A D D E N D U M

Project: EACS HS Classroom Renovations

Addendum No: 02

Date: 12-18-2024

PLAN NORTH
1 Second Floor Finishes Plan
 1/8" = 1'-0"

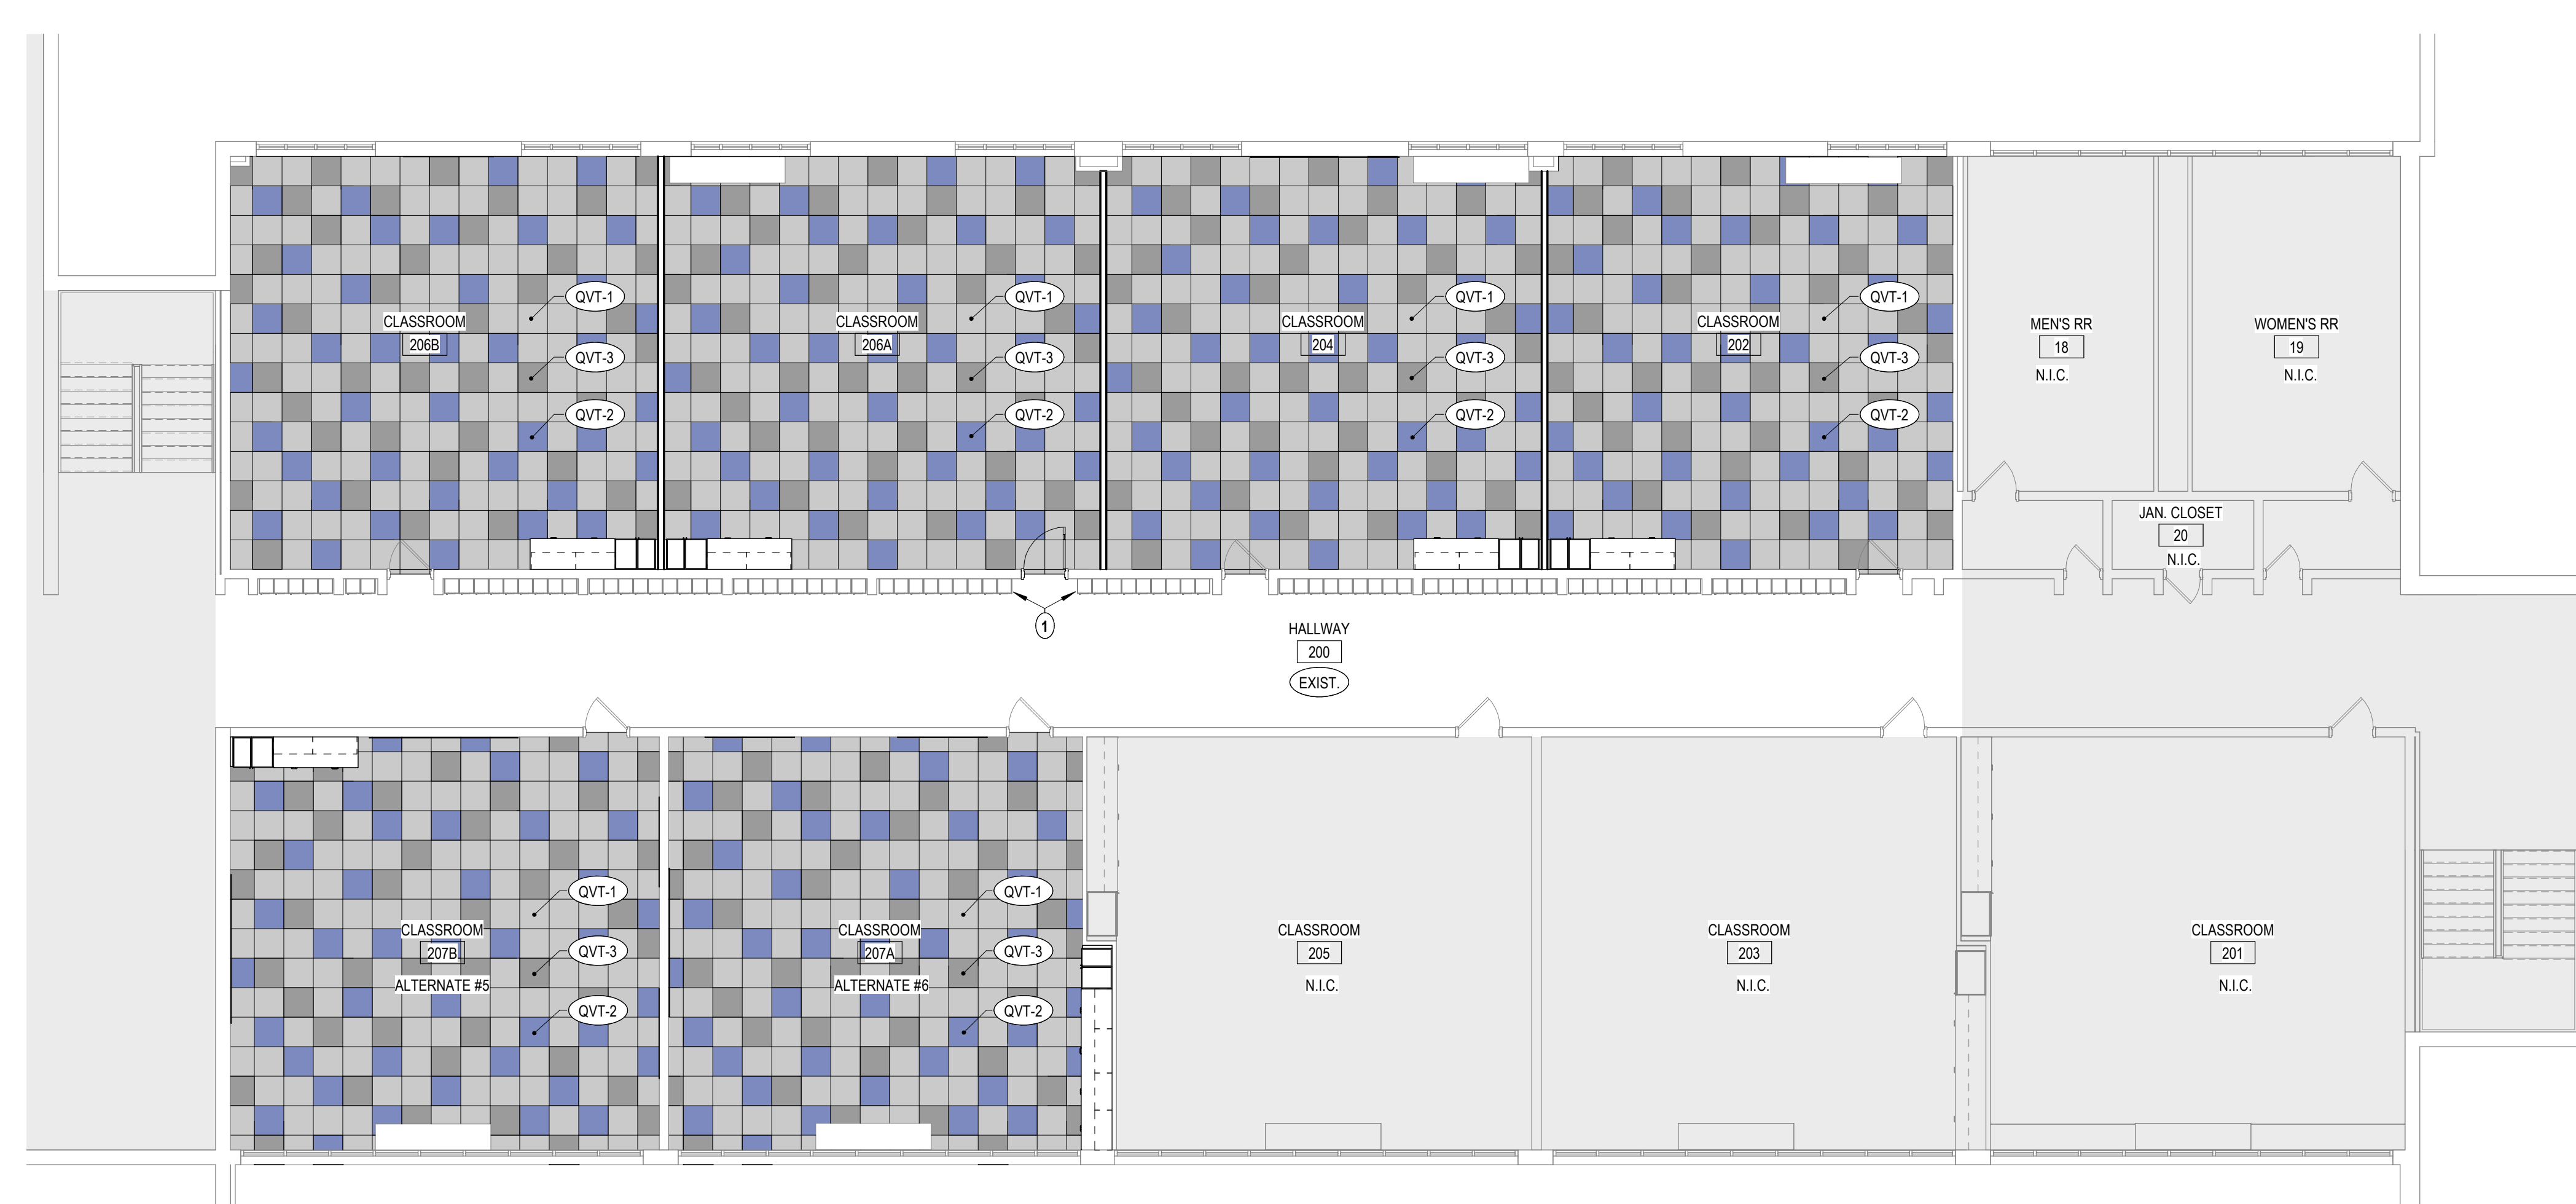
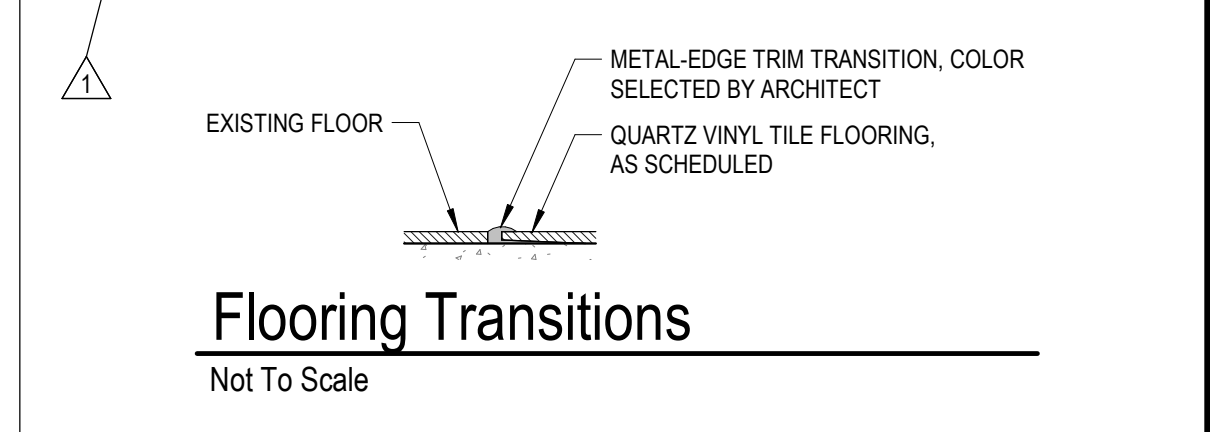
ITEM NO. 2.06 - DRAWING NO. A-141 Finishes Plan – Second Floor

- A. Revision of Finish Plan Note 1.

| 1 | INFILL FINISH FLOOR TO MATCH EXISTING WHERE EXISTING FLOOR IS DAMAGED BY WORK. REPAIR PATCH WALL SURFACES TO RECEIVE PAINT ALL EXPOSED WALL SURFACES AT CONCLUSION OF WORK. INSTALL BASE TO MATCH EXISTING AT CONCLUSION OF WORK. |

ISSUE DATE November 27, 2024
SECOND FLOOR MECHANICAL PLAN

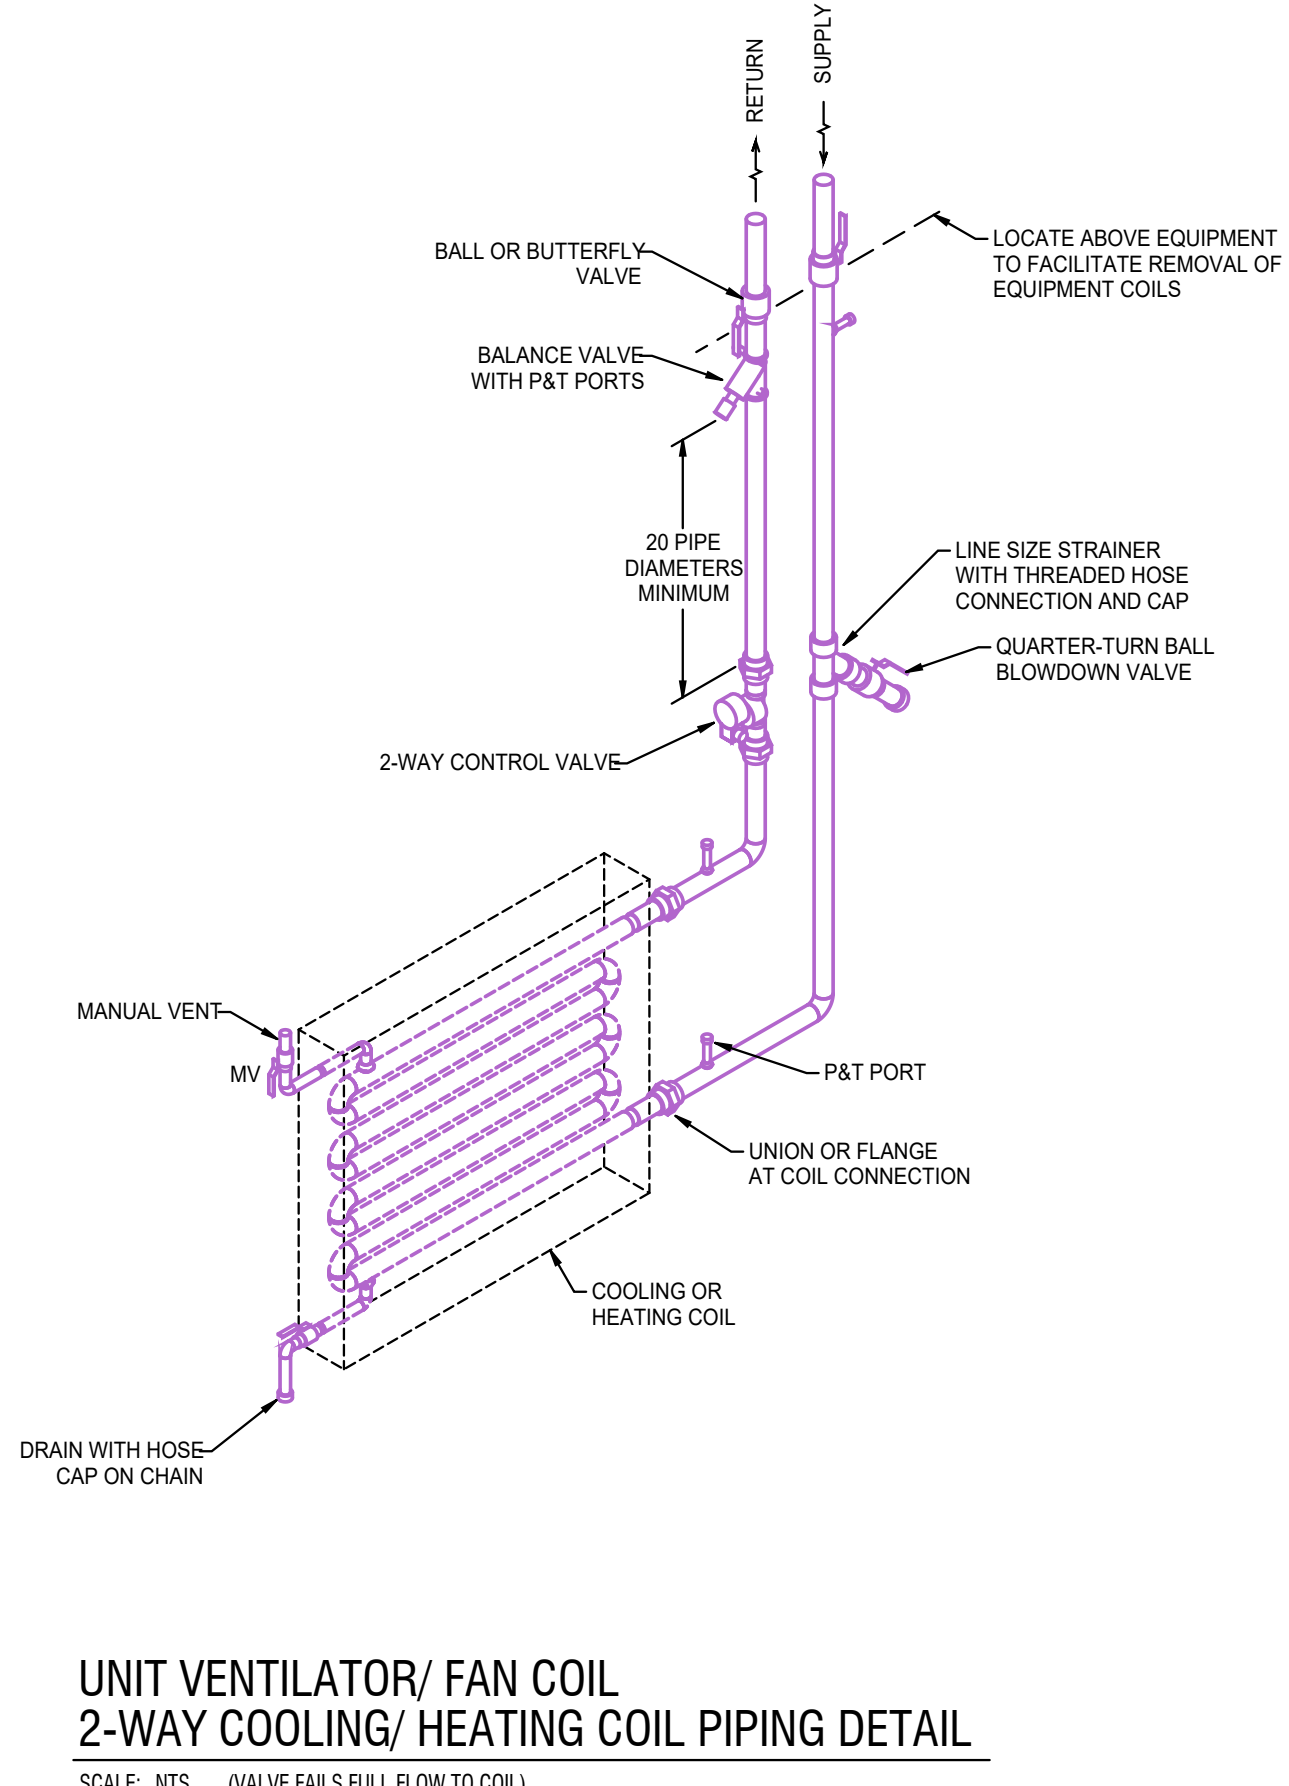
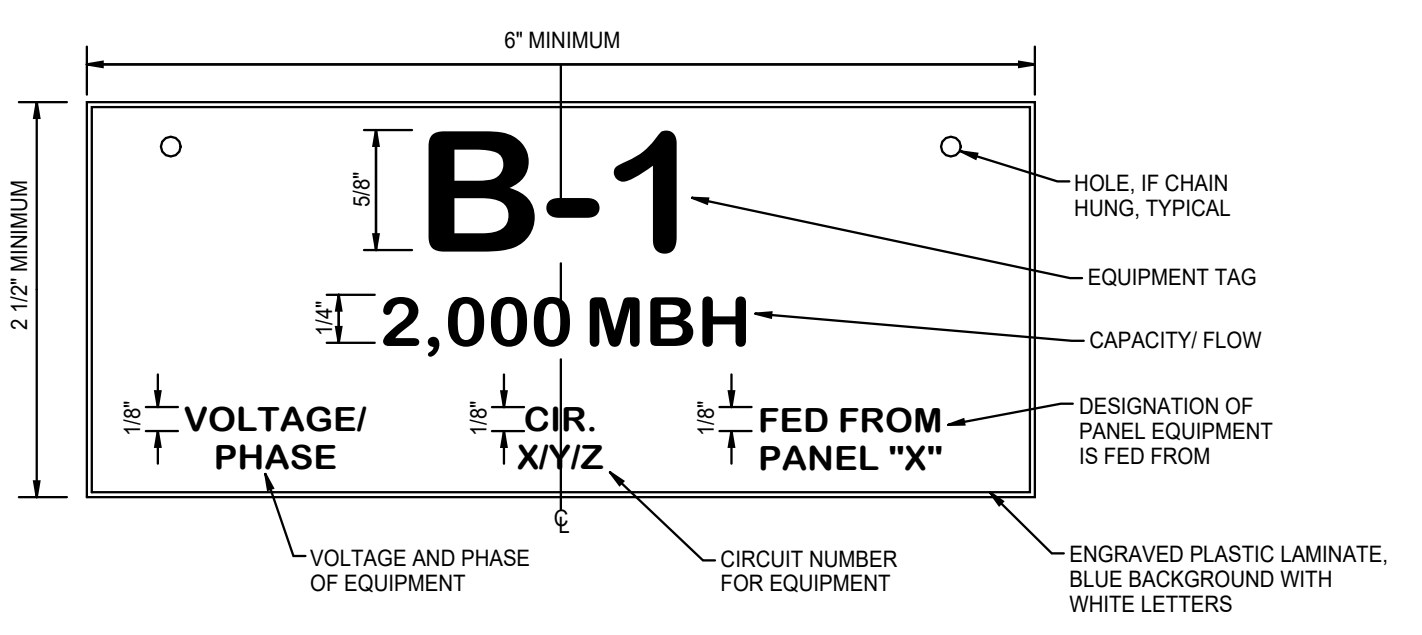
Item #3: Woodland HS: Drawing Sheet M101, "Second Floor Mechanical Plan":

- A. Added transfer grilles and openings above ceilings. Refer to drawing sheet M101 labeled Addendum #2 for more information.**

- PLAN NOTES**
- INSTALL NEW UNIT VENT AND TIE-IN TO EXISTING O.A. INTAKE LOUVER. SEAL UNIT TO WALL WITH GASKET TAPE. EXTEND HW CHW PIPING AND CONNECT TO UNIT IN EXTENDED PIPE COMPARTMENTS. MODIFY EXISTING PIPE CHASE ON WALL AS NEEDED.
 - INSTALL SALVAGED WALL SENSOR AND PROVIDE NEW WIRING/ PROGRAMMING TO EXISTING UNIT VENT.
 - ROUTE/ EXTEND CONTROL WIRING FROM EXISTING WALL SENSOR TO EXISTING UNIT VENT.
 - INSTALL NEW OPENING ABOVE CEILING MINIMUM 2" ABOVE CEILING.
